RECOMMENDATION MEETING **DRAFT**

12554 Lake City Way NE Seattle, WA 98125

3039593-LU
3039896-EG

NORTH NEIGHBOR STUDY

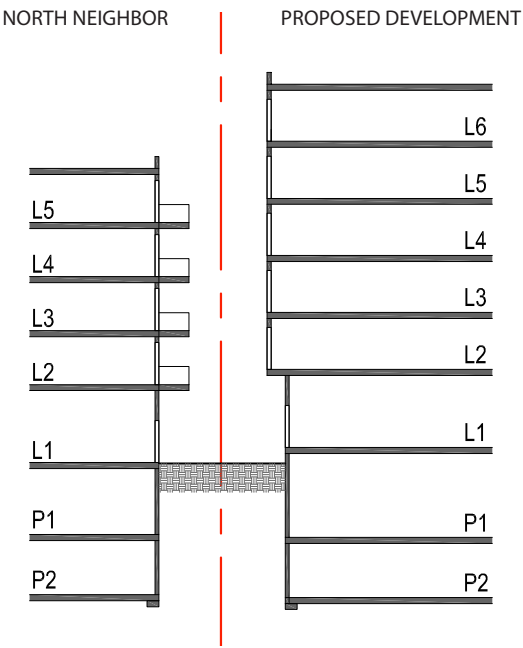
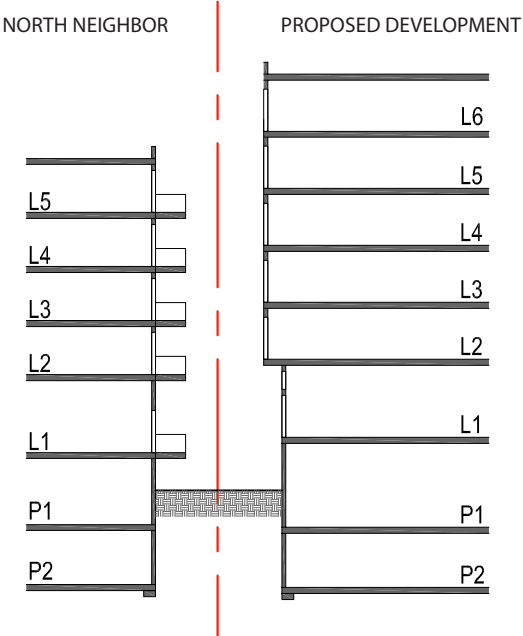
The board indicated preliminary support for the requested departure, granted that the guidance regarding further analysis of the north and south adjacency conditions is resolved and the north and south facades are further developed to provide greater relief. (CS1-I responding to site characteristics, CS2-B-1 site characteristics, CS2-D height, bulk, and scale)

The length of the proposed development's facade is less than 2/3 of that of the north neighbor's. Due to the different floor heights and window placements, the windows of both properties are not directly facing one another. The proposed development's facade utilizes modulation to provide relief for adjacent neighbors and to prevent a flat facade.
